SUBJECT: ISSUANCE OF AMENDMENT NO. 113 TO FACILITY OPERATING LICENSE NO. NPF-12 REGARDING PRESSURE/TEMPERATURE LIMITS - VIRGIL C. SUMMER NUCLEAR STATION, UNIT NO. 1 (TAC NO. M84745)

AMENDMENT NO. 113 TO FACILITY OPERATING LICENSE NO. NPF-12 - SUMMER, UNIT NO. 1

SAFETY EVALUATION BY THE OFFICE OF NUCLEAR REACTOR REGULATION

Figure 3.4-2 V. C. Summer Unit 1 Reactor Coolant System Heatup Limitations (Heat up rates up to 50 and 100°F/hr) Applicable for the First 14 EFPY (With Margins 10°F and 60 psig For Instrumentation Errors)

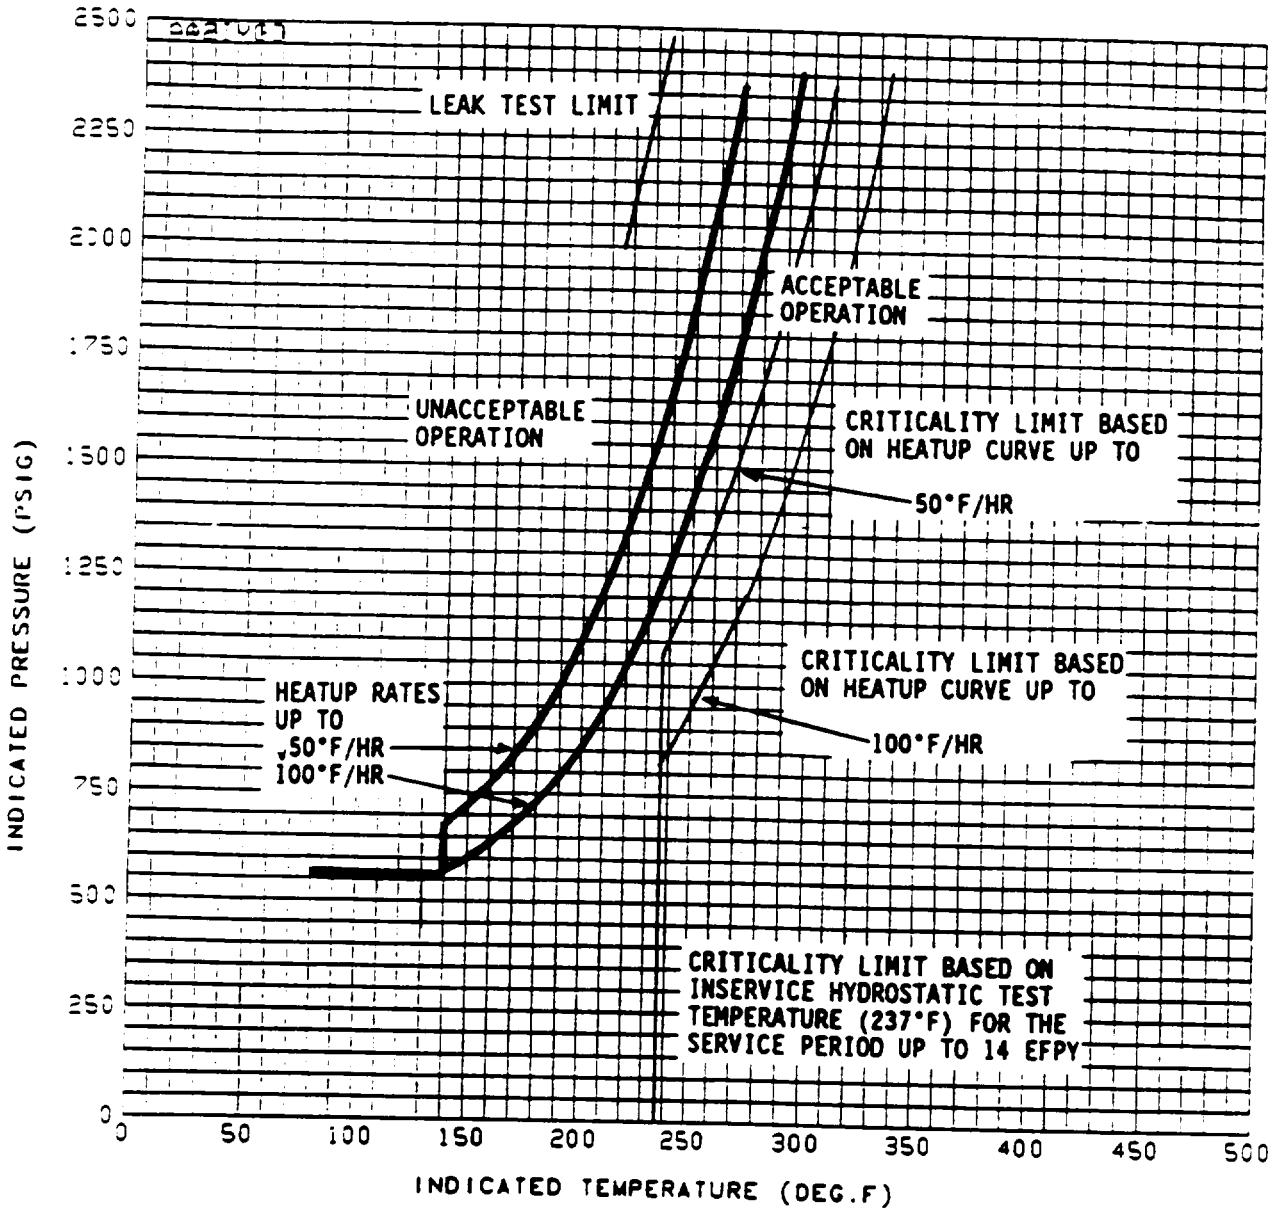
The amendment modifies Figures 3.4-2 and 3.4-3 of TS 3/4.4.9, Pressure/Temperature Limits, Reactor Coolant System, it also removes Table 4.4-5, "Reactor Vessel Material Surveillance Program - Withdrawal Schedule," and to remove the reference to this table in Surveillance Requirement 4.4.9.1.2.

The changes to the Pressure/Temperature (P/T) limits provide new heatup and cooldown curves based on the analysis of specimen X of the radiation surveillance program. The request to remove Table 4.4-5 is based on the guidance of Generic Letter 91-01 (GL 91-01), "Removal of the Schedule for Withdrawal of Reactor Vessel Material Specimens from Technical Specifications."

The requested changes to the Pressure/Temperature (P/T) limits would provide new heatup and cooldown curves based on the analysis of specimen X of the Summer Station radiation surveillance program. The request to remove Table 4.4-5 is based on the guidance of Generic Letter 91-01 (GL 91-01), "Removal of the Schedule for Withdrawal of Reactor Vessel Material Specimens from Technical Specifications."

Throughout the life of the reactor vessel, material irradiation surveillance specimens are removed and examined to determine changes in material properties. The results of the examination of these specimens may warrant a change to the heatup and cooldown curves (P/T limit curves) associated with the reactor vessel. Strict adherence to proper heatup and cooldown curves is necessary to ensure vessel integrity under normal and transient conditions. In accordance with the TS for Summer Station, surveillance specimen X was removed during refueling outage 5. Analysis of this specimen has indicated that a change to the P/T limit curves is appropriate. In effect, the changes to the curves increase the reference transition temperature by approximately 10°F.

The calculations performed in the development of the proposed P/T curves were made using the guidance of Regulatory Guide 1.99, Revision 2, "Radiation Embrittlement of Reactor Vessel Materials," and Appendix G to 10 CFR Part 50, "Fracture Toughness Requirements." The staff has reviewed the proposed changes and has

determined that they continue to provide conservative limits on the reactor coolant system pressure and temperature in accordance with the requirements of Section V of Appendix G to 10 CFR Part 50. The changes are, therefore, acceptable.
